Office Action Summary	Application No. 10/591,084	Applicant(s) ASTIZ MONTOYA ET AL.	
	Examiner JORGE PEREIRO	Art Unit 3743

DETAILED ACTION

2. Claims 27-37, 40-45, and 48-52 are rejected under 35 U.S.C. 102(b) as being anticipated by French Patent 2,239,916 to Antargaz Distribution (“Antargaz”).

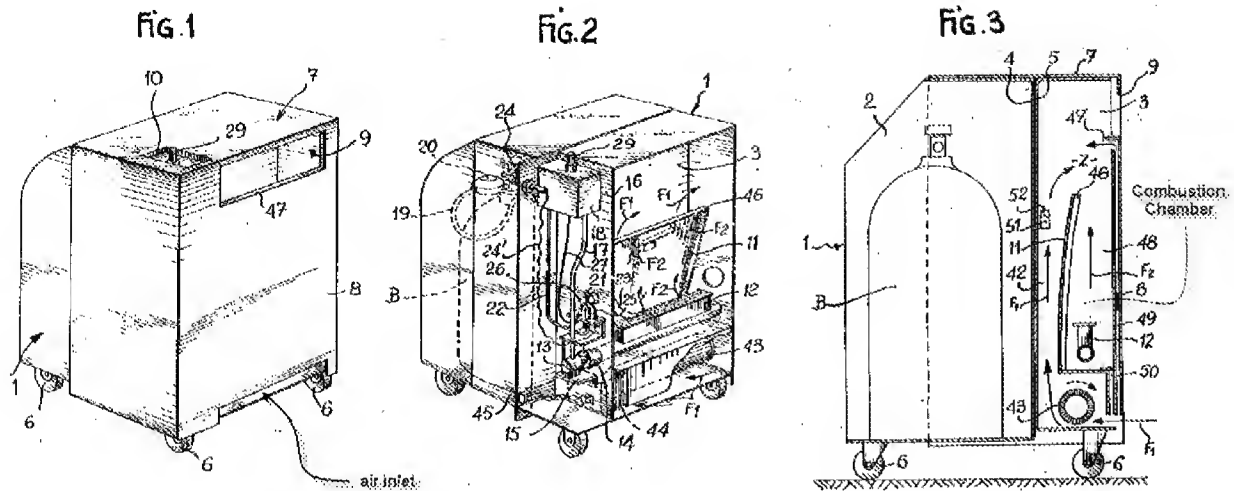
3. In re claim 27, with reference to figures 1-3 below, Antargaz discloses a gas heating device (1) comprising: a gas burner (12) including a combustion chamber (referenced in figure 3 below) for the flames of the gas burner; and a convection air conduit (3) including an air outlet (9) evacuating a convection air stream (F1) that has been heated in the gas heating device, the combustion chamber of the gas burner being in fluid-flow communication with the convection air conduit and mixing an exhaust gas stream from the combustion chamber with the convection air stream (*see at least* figure 3).

4. In re claim 28, with reference to figures 1-3 above, Antargaz discloses all of the claim limitations including wherein the gas burner (12) is located inside the convection air conduit (3).

5. In re claim 29, with reference to figures 1-3 above, Antargaz discloses all of the claim limitations including wherein the convection air conduit (3) includes a first air duct (48) and a second air duct (42).

6. In re claim 30, with reference to figures 1-3 above, Antargaz discloses all of the claim limitations including wherein the gas burner (12) faces the first air duct (48).

7. In re claim 31, with reference to figures 1-3 above, Antargaz discloses all of the claim limitations including wherein the second air duct (42) is located behind the gas burner (12).

8. In re claim 32, with reference to figures 1-3 above, Antargaz discloses all of the claim limitations including wherein a control element (52) is located in the second air duct (42).

9. In re claim 33, with reference to figures 1-3 above, Antargaz discloses all of the claim limitations including wherein at least one swirling element (46) is arranged in the air duct (48) which adjusts a residence time of secondary air in the area of the gas burner (12).

10. In re claim 34, Antargaz discloses all of the claim limitations including wherein the swirling element (46) at least partially surrounds the gas burner (12) in a funnel shape (see figures 2 and 3 above).

11. In re claim 35, with reference to figures 1-3 above, Antargaz discloses all of the claim limitations including wherein the convection air conduit (3) is arranged substantially perpendicularly in the gas heating device.

12. In re claim 36, with reference to figures 1-3 above, Antargaz discloses all of the claim limitations including wherein the gas burner (12) comprises a burner plate including a plurality of flame outlet openings (see figure 2 above).

13. In re claim 37, with reference to figures 1-3 above, Antargaz discloses all of the claim limitations including wherein the convection air conduit (3) is at least partly defined by a heat-resistant, radiation-transmitting element (49).

14. In re claim 40, with reference to figures 1-3 above, Antargaz discloses all of the claim limitations including wherein at least one flow guiding element (11) is provided in the convection air conduit (3) protecting heat-sensitive locations (51, 52) of the gas heating device from the convection air stream (F2).

15. In re claim 41, with reference to figures 1-3 above, Antargaz discloses all of the claim limitations including wherein the gas heating device (1) comprises at least one of an installation compartment (2) for a gas bottle (B) and rollers (6) disposed on a bottom portion of the gas heating device (1).

16. In re claim 43, with reference to figures 1-3 above, Antargaz discloses all of the claim limitations including wherein the gas heating device (1) comprises a housing provided with a hood-like front housing portion (7).

17. In re claim 44, with reference to figures 1-3 above, Antargaz discloses all of the claim limitations including wherein the front housing portion (7) at least partly defines the convection air conduit (3).

18. In re claim 45, with reference to figures 1-3 above, Antargaz discloses all of the claim limitations including wherein the air outlet (9) and air inlet (referenced in figure 1 above) are provided in the front housing portion (7).

19. In re claim 48, with reference to figures 1-3 above, Antargaz discloses all of the claim limitations including wherein at least one of a flow element and a swirling element (47) is arranged on the front housing portion (7).

20. In re claim 49, with reference to figures 1-3 above, Antargaz discloses all of the claim limitations including wherein the convection air conduit (3) is embodied as a vertical shaft in the gas heating device (1).

21. In re claim 50, with reference to figures 1-3 above, Antargaz discloses all of the claim limitations including further comprising a dividing wall (4, 5) and the convection air conduit (3) being disposed between the dividing wall and the housing front portion (7).

22. In re claim 51, with reference to figures 1-3 above, Antargaz discloses all of the claim limitations including wherein the air outlet (9) is at least partly provided on the gas heating device (1) at the top.

23. In re claim 52, with reference to figures 1-3 above, Antargaz discloses all of the claim limitations including wherein a flow element (46, 47) is provided between the gas burner (12) and the air outlet (9) protecting the gas burner from incoming water.

24. In re claim 53, with reference to figures 1-3 above, Antargaz discloses all of the claim limitations including further comprising a housing provided with a hood-like front housing portion (7), the front housing portion at least partly defines the convection air conduit (3), the air outlet (9) and air inlet (referenced in figure 1 above) are provided in the front housing portion, the convection air conduit includes a first air duct (48) and a second air duct (42), the gas burner faces the first air duct (*see* figure 3), the second air duct is located behind the gas burner (*see* figure 3), and the air inlet (referenced in figure 1 above) is communicated (*see* fuel/air mixing tube 14, figure 2) with the gas burner in a manner to provide a secondary air stream to the gas burner for combustion thereby with the secondary air stream reaching the gas burner without any mixing of the secondary air stream with air that has traveled along the second air duct (42) located behind the gas burner (*see* figures 1-3).

45. However, with reference to figures 1-3 above, Antargaz discloses a gas heating device (1) in which the convection air conduit (3) includes an air outlet (9) evacuating a convection air stream (F1) that has been heated in the gas heating device and the combustion chamber (referenced in figure 3 above) of the gas burner (12) is in fluid-flow communication with the

convection air conduit (3) and mixes an exhaust gas stream (F2) from the combustion chamber with the convection air stream (F1).

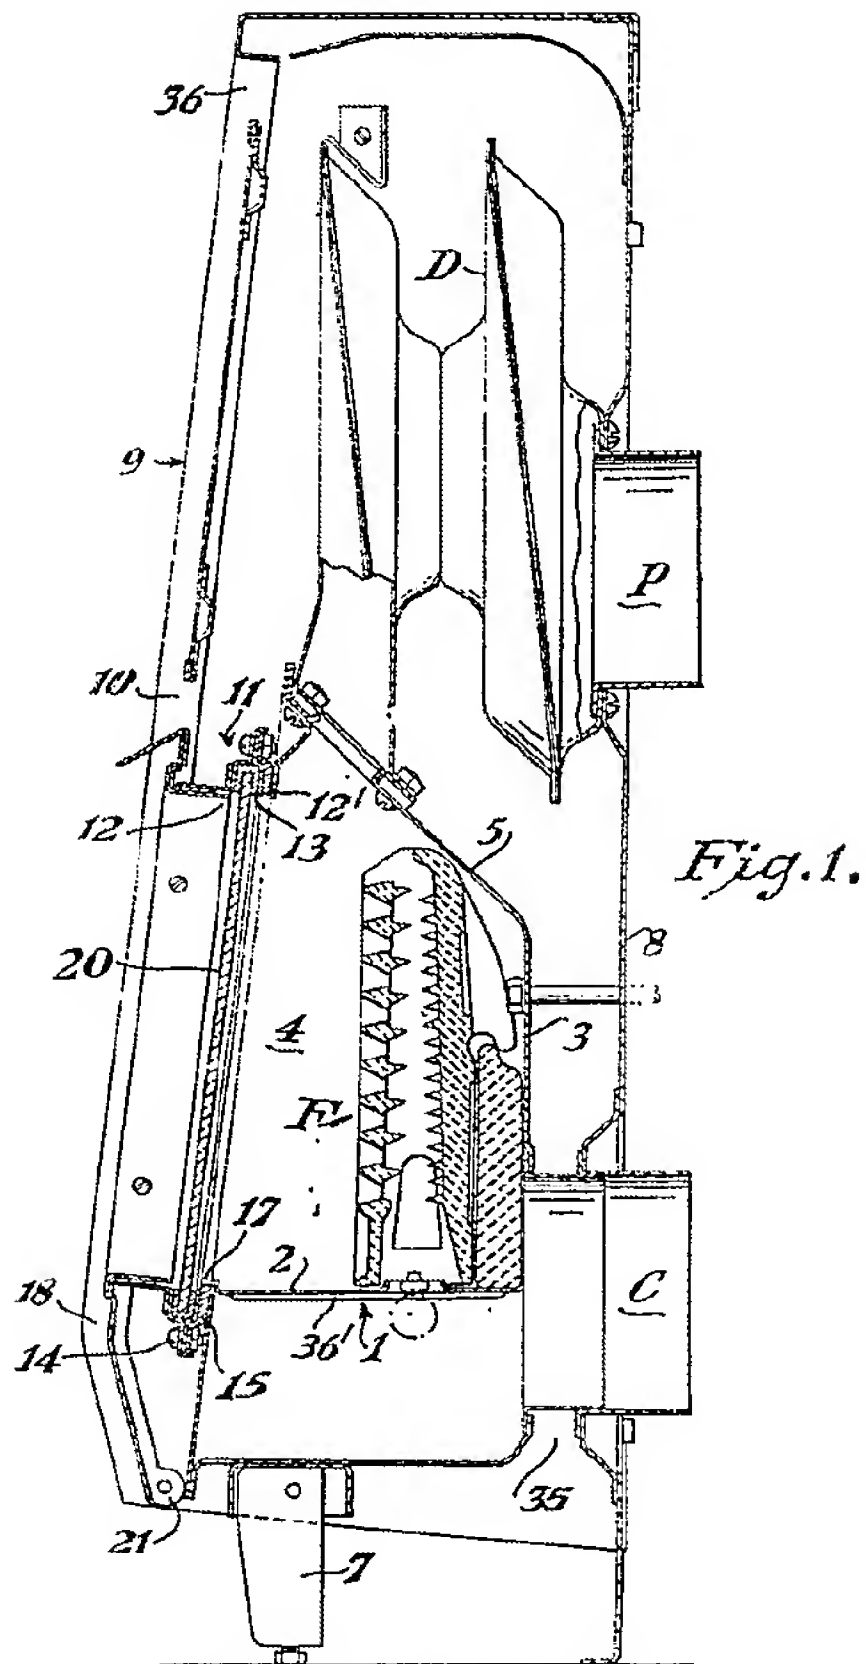
30. Nonetheless, with reference to figure 1 below, Fuidge discloses a gas space/room heater that heats by both radiation and convection wherein a radiation-transmitting element (20) is a square/rectangle formed from at least one of glass and glass ceramic (see page 2, lines 119-129).

35. In re claim 39, with reference to figure 1 of Fuidge above, Antargaz in view of Fuidge discloses all of the claim limitations including wherein the radiation-transmitting element (20) is located in a direction of thermal emission of the gas burner (F).

37. Nonetheless, with reference to figure 1 of Fuidge above, Fuidge discloses a gas space/room heater that heats by both radiation and convection wherein a window-like recess (12) is provided in the front housing portion (9) in the direction of thermal radiation of the gas burner (F).

39. In re claim 47, with reference to figure 1 of Fuidge above, Antargaz in view of Fuidge discloses all of the claim limitations including wherein the radiation window (12) of the front housing portion is closed by means of a radiation-transmitting square or rectangle (20).
